AGENDA
CITY OF GLENWOOD SPRINGS
Planning and Zoning Commission
Regular Meeting
DECEMBER 17, 2019
Council Chambers, First Floor
101 W. 8TH STREET
6:00 PM

Date: December 17, 2019
 To: Planning and Zoning Commission
 From: Trent L. Hyatt, Senior Planner
 Subject: #39-19– Roaring Fork Transportation Authority Phase II

Regional Transit Center
Location and Extent Review Application
Revised Based on COGS Comments
December 09, 2019

NAME OF PROJECT: RFTA RTC GMF Renovation Phase 2
BID PACKAGE: N/A
DESIGN PACKAGE: COGS L&E Review Application -
Revisions & Comment Responses

Drainage Issue Resolution

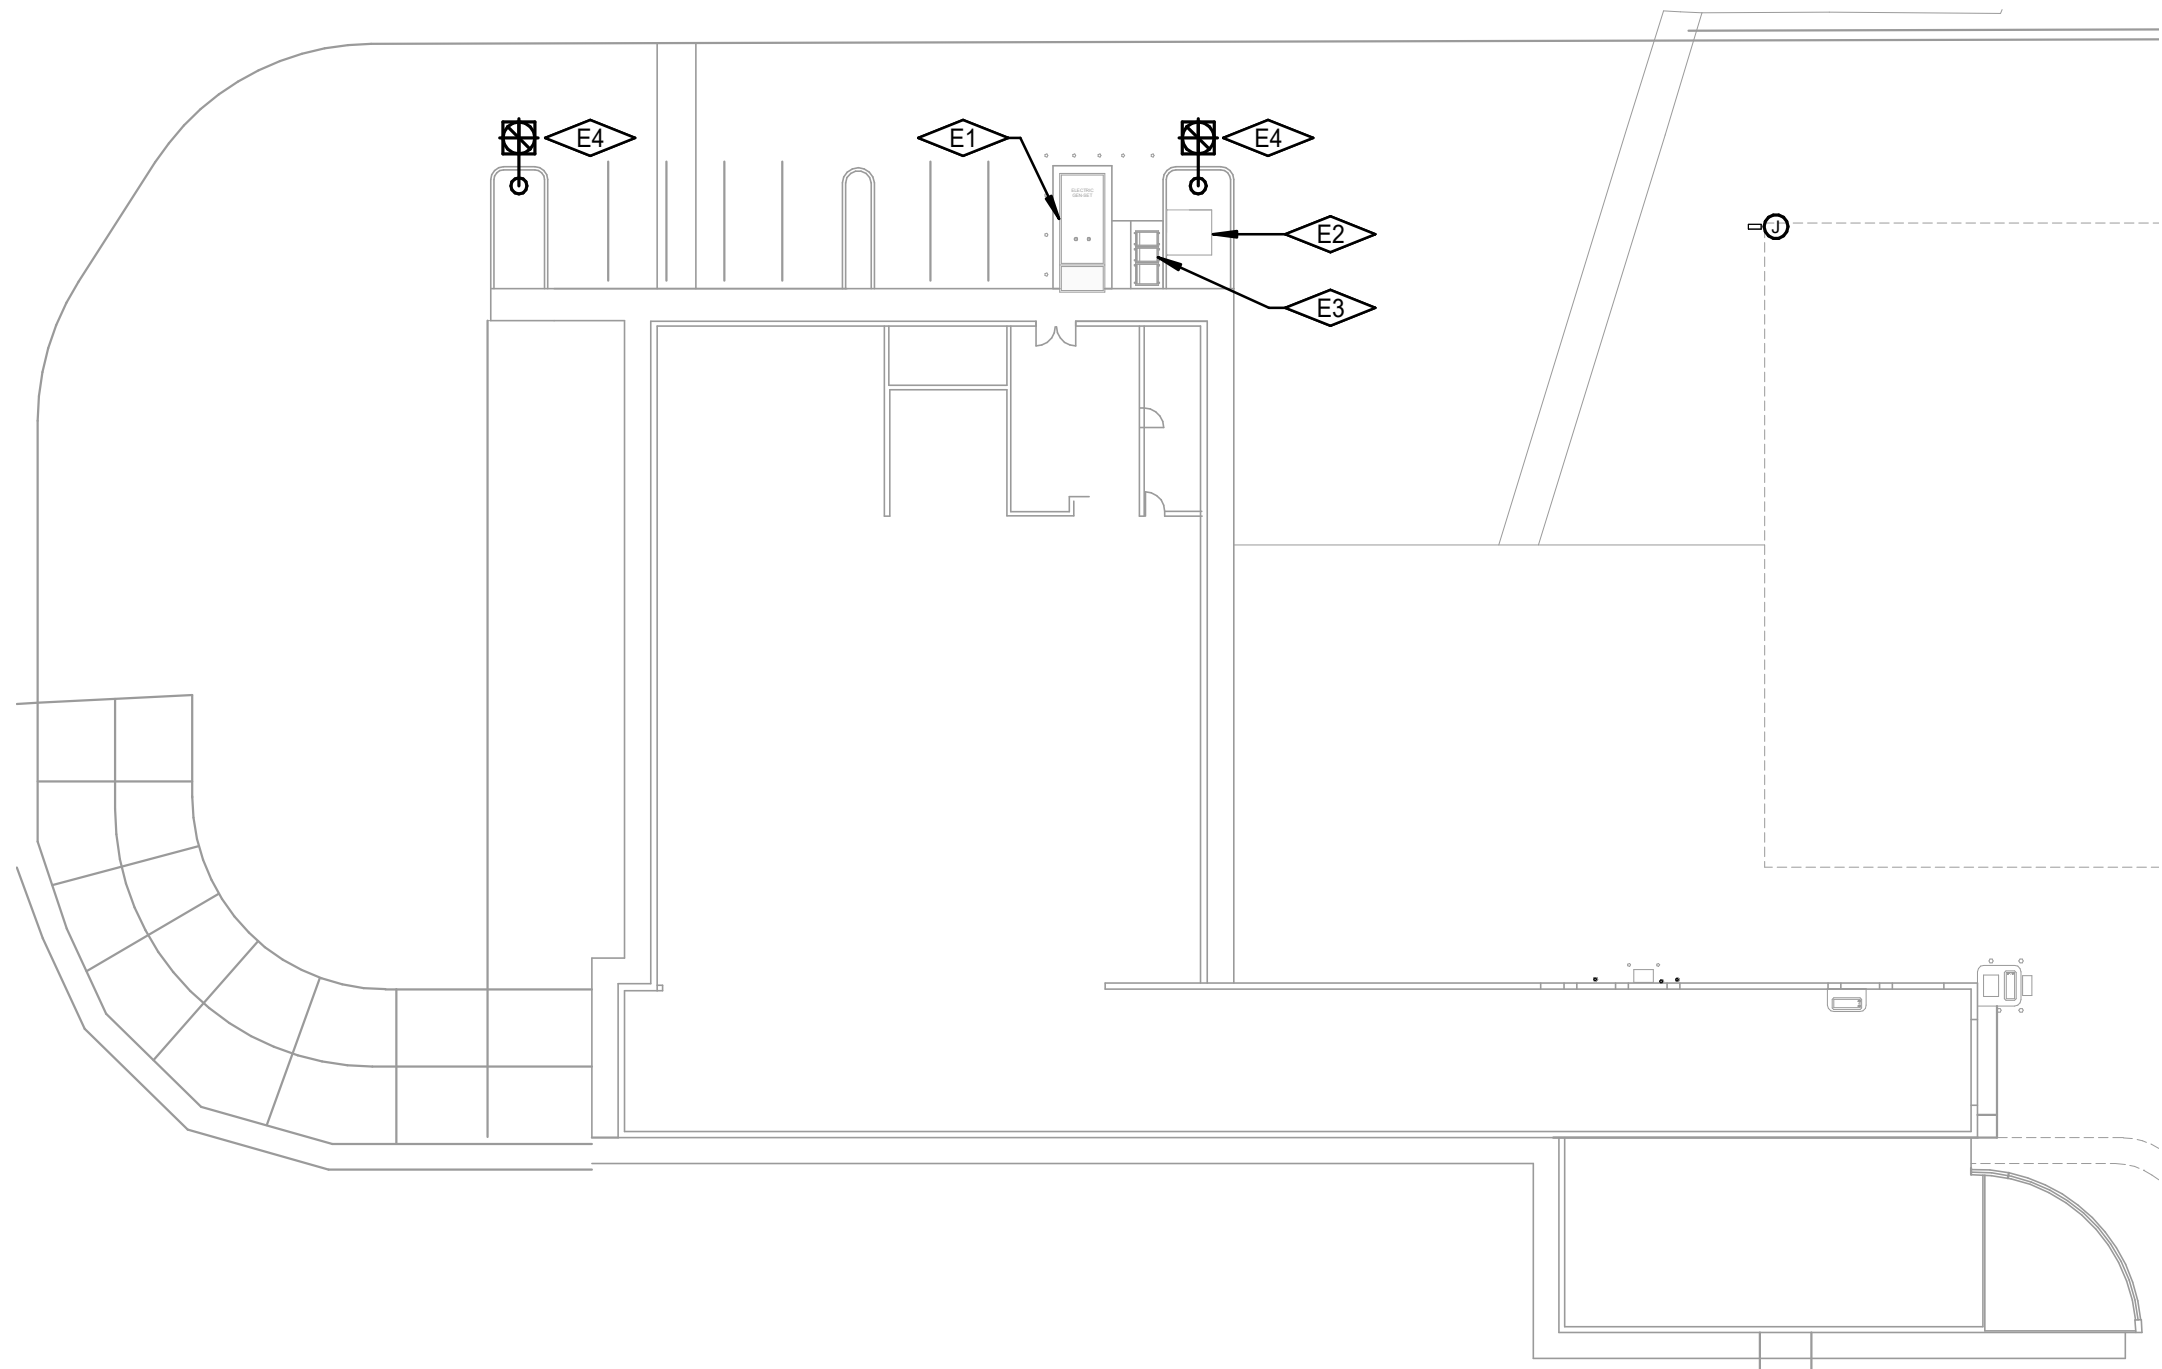
Engineering Department - Comments received outline items required prior to the issuance of a grading and/or building permit in the future. Additional, comments address an ongoing drainage issue related to sediment which impacts the City's wastewater treatment plant access.

As requested the 100% design will incorporate new features to solve the drainage issue at the swale at the northeast section of the site, i.e. necessary inlets and piping will be constructed to divert all runoff westward to existing drainage features so that runoff does not proceed northward down the slope in the current situation.

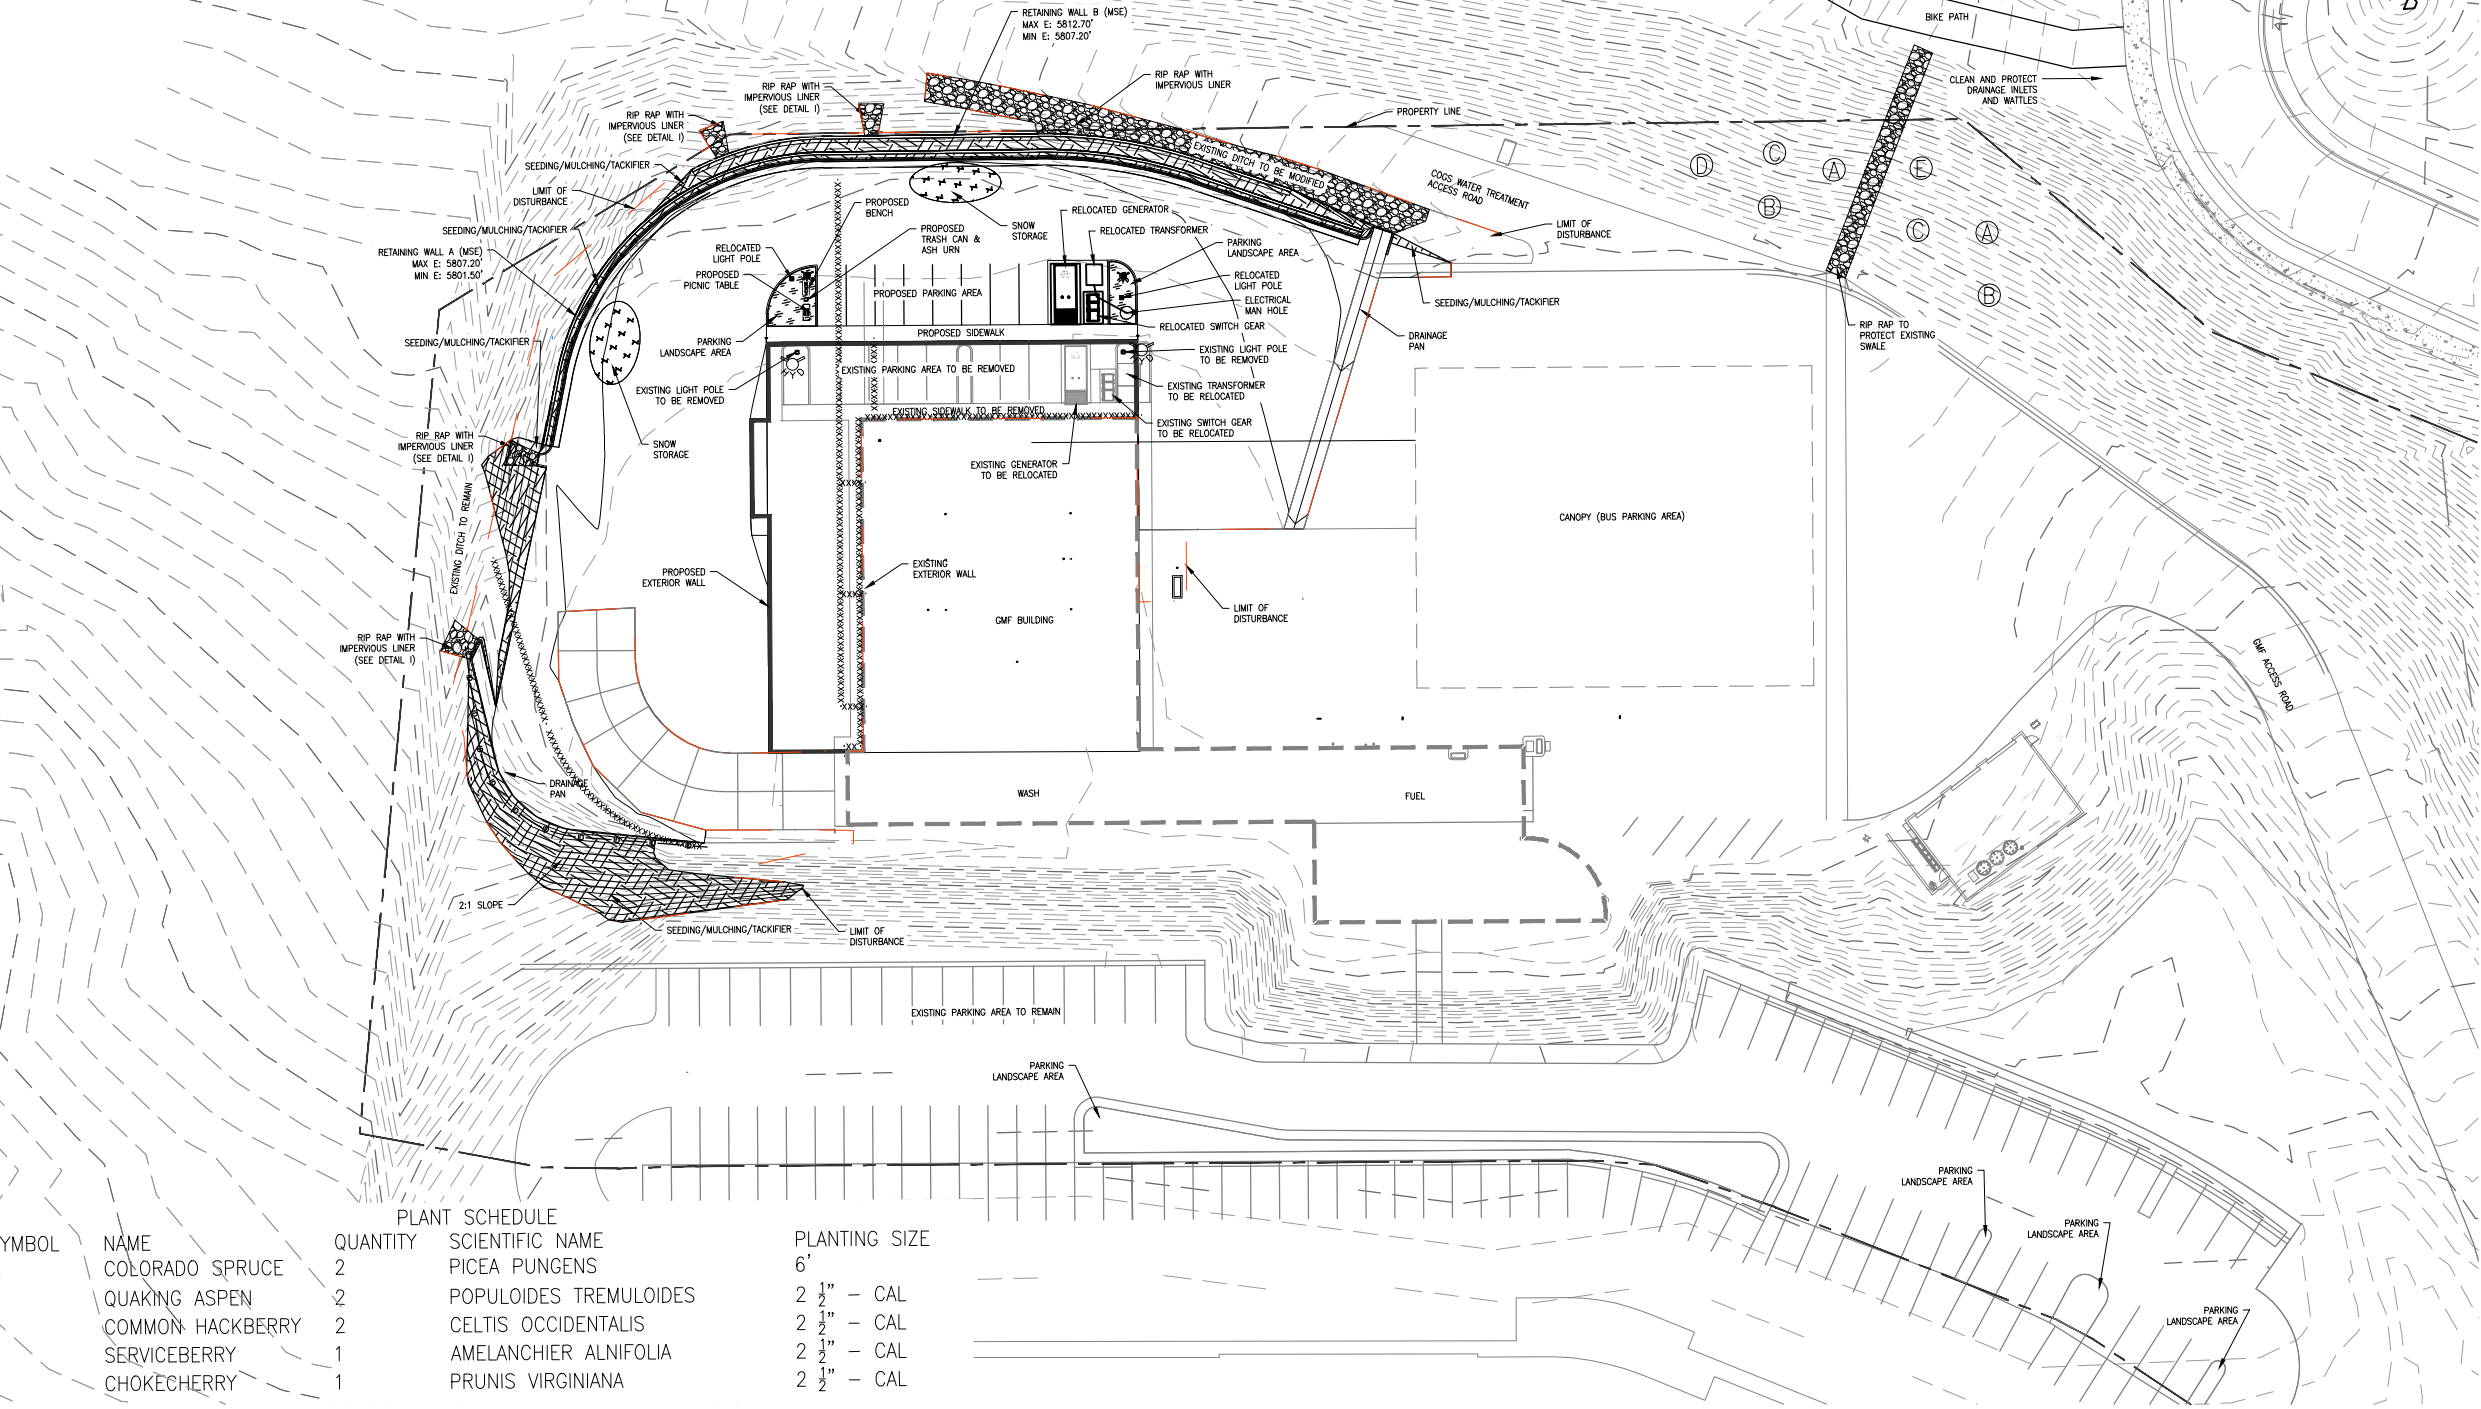
Expansion of parking/circulation areas at the site require landscaping improvements per the Code. However, the presence of the geologic hazards outlined above make irrigation and introducing water to site soils a very risky proposition. Therefore, the applicant is only proposing limited landscaping improvements in areas that will not impact the built environment as depicted on the landscaping plan provided.

To reiterate, because of the unique geological hazards, in particular, the presence of collapsible soils at the site, RFTA requests a waiver from the landscaping planting requirements and proposes landscaping planting as shown in sheet C09.01 – Landscaping Plan for this project.

LANDSCAPING NOTE: BECAUSE OF THE UNIQUE GEOLOGICAL HAZARDS, IN PARTICULAR, THE PRESENCE OF COLLAPSIBLE SOILS AT THE SITE, RFTA REQUESTS A WAIVER FROM THE LANDSCAPING PLANTING REQUIREMENTS OF THE GLENWOOD SPRINGS MUNICIPAL CODE, SECTION 070.040.050 (LANDSCAPING, SCREENING, AND FENCING) AND PROPOSES LANDSCAPING PLANTING AS SHOWN ON THIS SHEET. FOR THE PURPOSES OF THE COGS L&E PROCESS, PLEASE REFER TO THE NARRATIVE SECTION FOR THE REQUESTED CHARTS.

2 NORTH ELEVATION
1/8" = 1'-0"

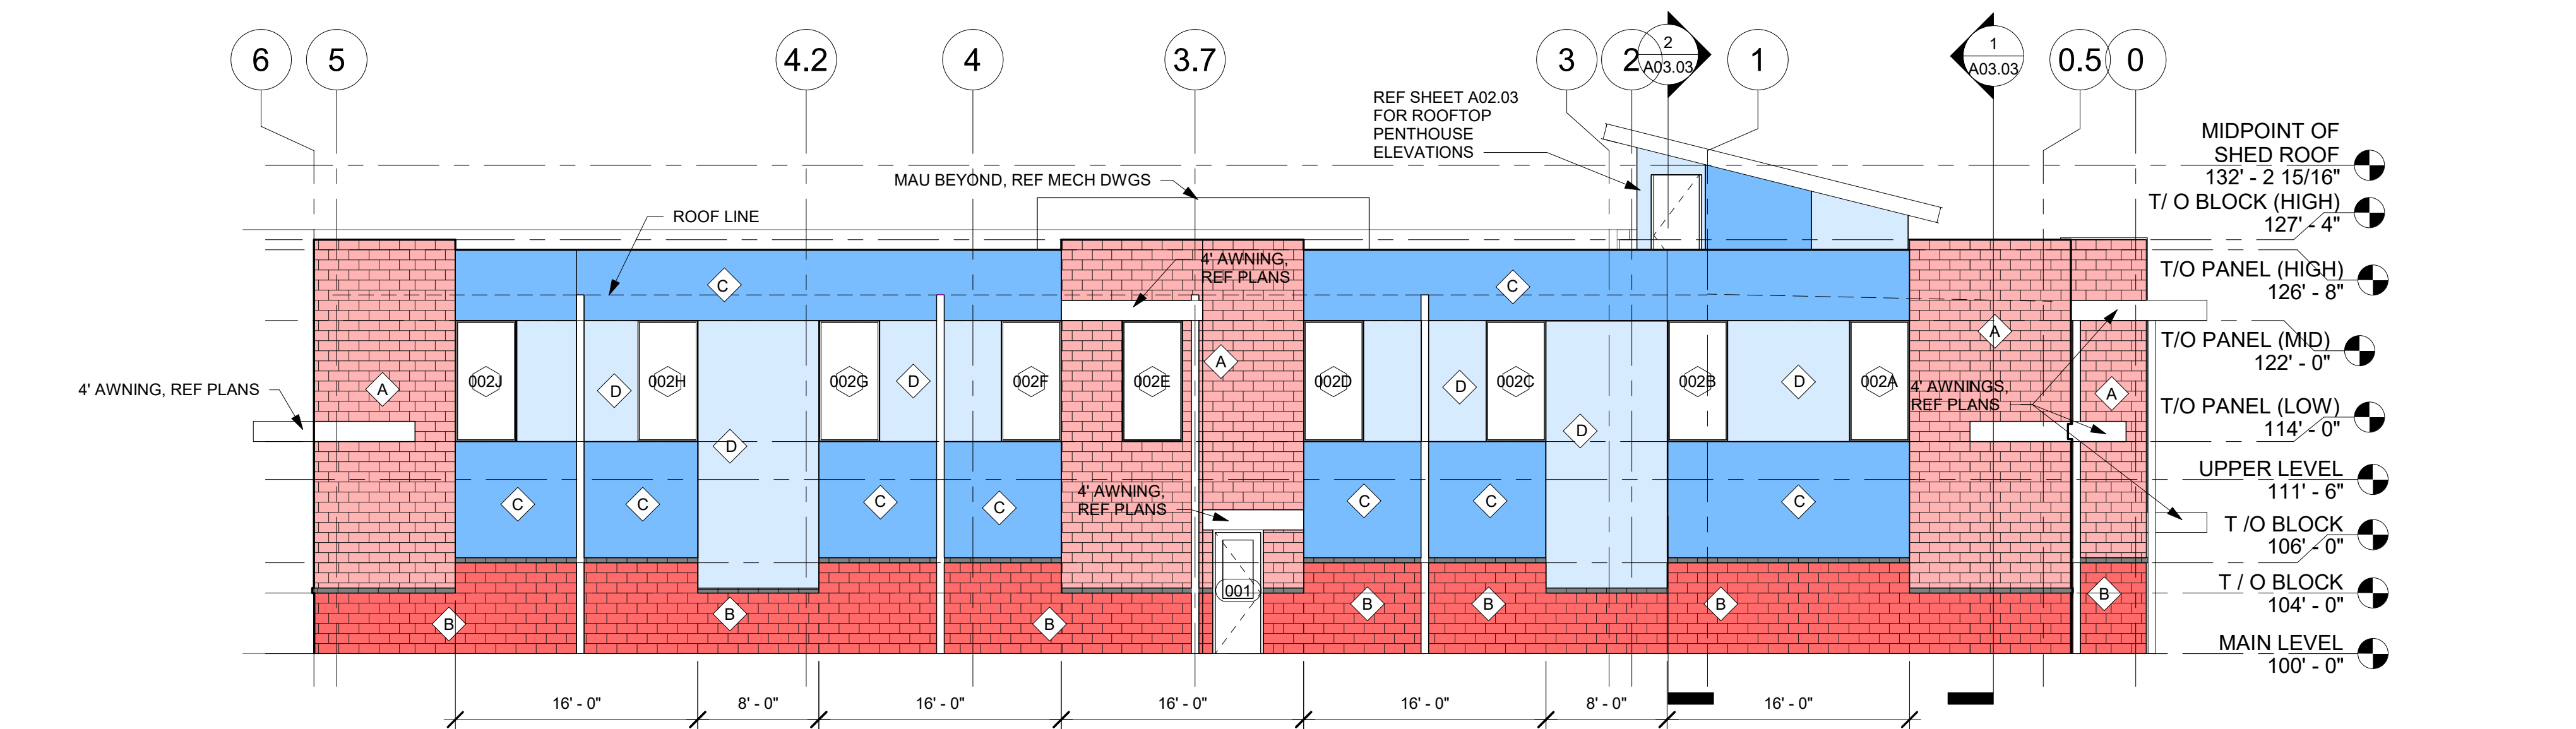
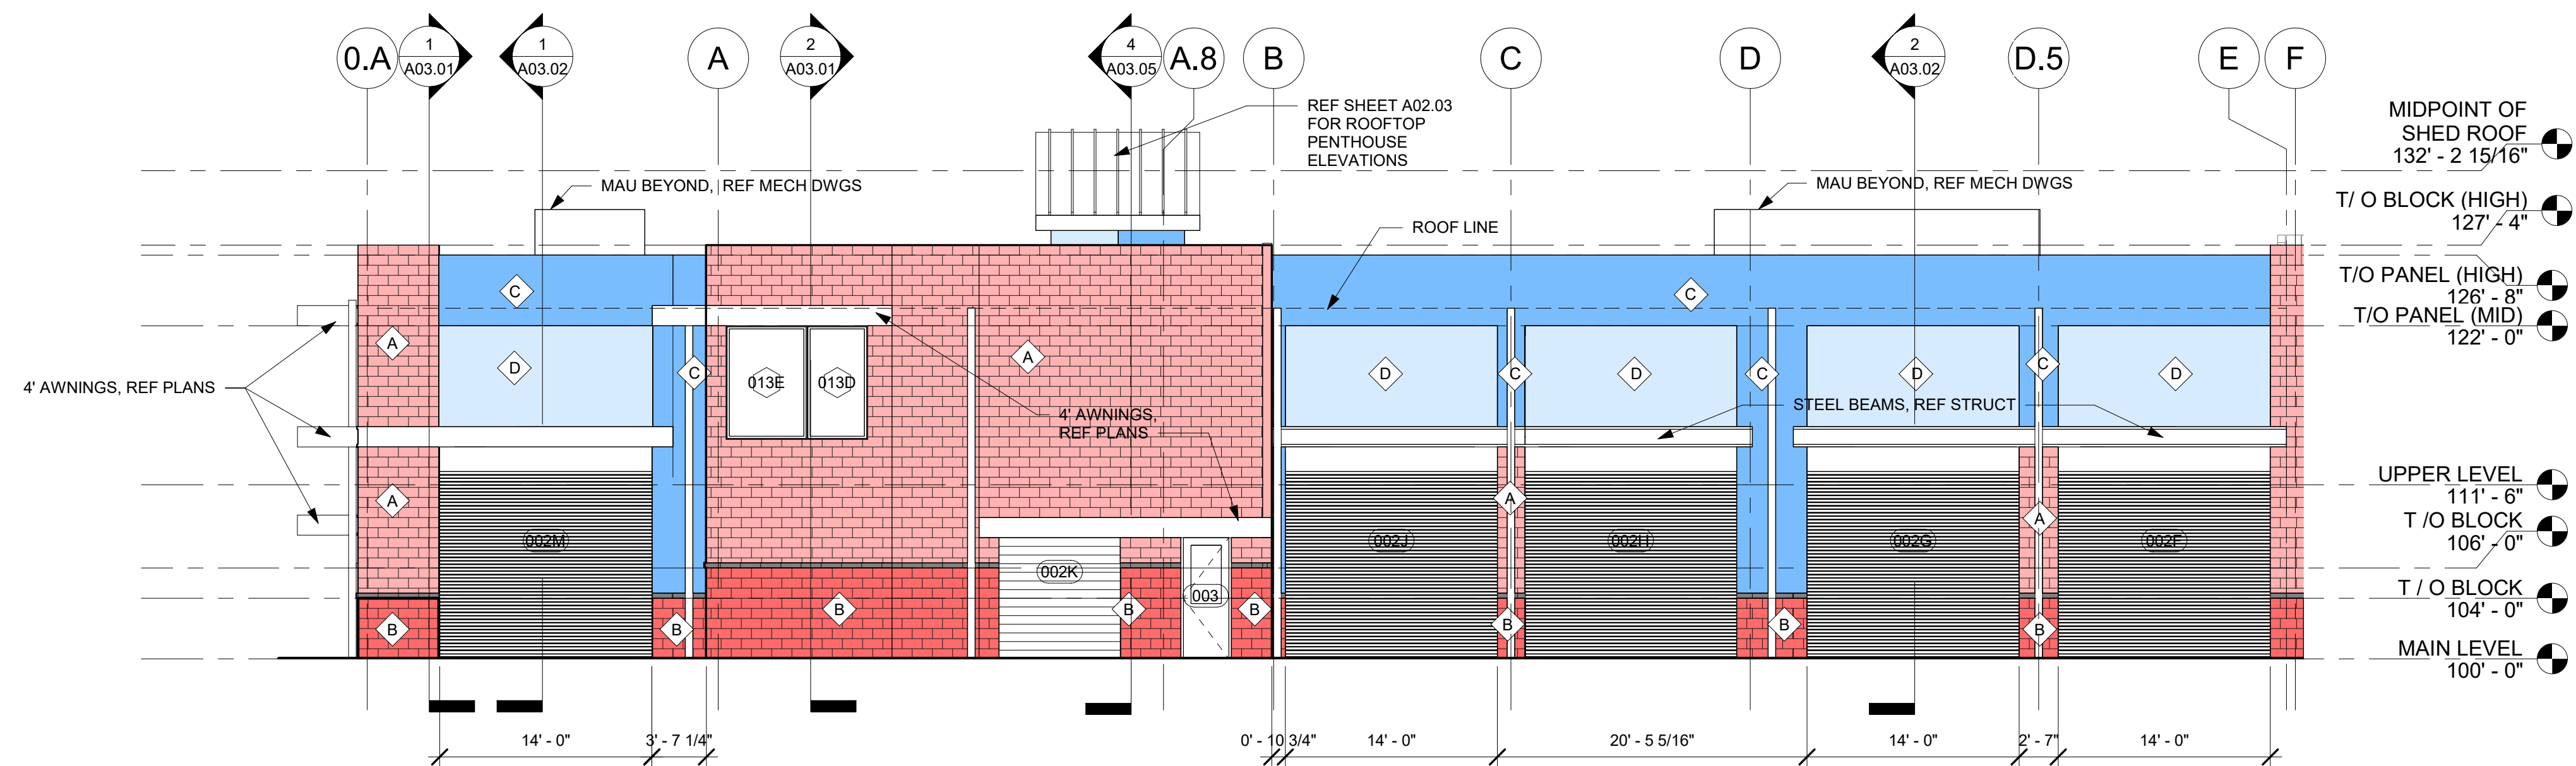
2					<i>Roof shall not extend 50 feet in length without incorporating projections/recessions/dormers or change in height or at least two feet. Please clarify.</i>	Zehren	This should not be applicable as we have a flat roof with parapets (4.c.) Parapets shall vary by 24 minimum. This may have some structural impact for wind loading and snow drifting as our minimum parapet height is 30” so our maximum height will change to 4’6”- 5’-0”.	
3					<i>Please call out the maximum building height to the midpoint of the shed roof as opposed to the top of the second level (sheets A02.01 and A02.02).</i>	Zehren	Included on sheets A02.01 and A02.02.

No.	Disc	PAGE/SHEET REFERENCE	DESCRIPTION	CO	COMMENT	CR	RESPONSE	RESOLUTION DATE
4					<i>Please provide dimensions for each side of the building on each elevation</i>	Zehren	Included on sheets A02.01 and A02.02.	
5					<i>Please add the elevation coverage percentage tables provided in the project description narrative to each respective elevation sheet</i>	Zehren	Added to each sheet, A02.01 and A02.02.	
6					<i>It appears that various walls include glazing (windows/doors) not included in the tables provided. Please clarify.</i>	Zehren	Glazing included.	
7					<i>Please provide a colored elevation or a separate sheet which depicts the color of proposed building materials.</i>	Zehren	Included on sheets A02.01 and A02.02.	
8					<i>Please provide a detail of the proposed retaining walls.</i>	BM/ER/ NS	MSE retaining wall detail already included in initial L&E application package as sheet no C07.01. As discussed with TH for clarification on 11/27: the detail is supplemented with photos of the existing wall at the P&R.
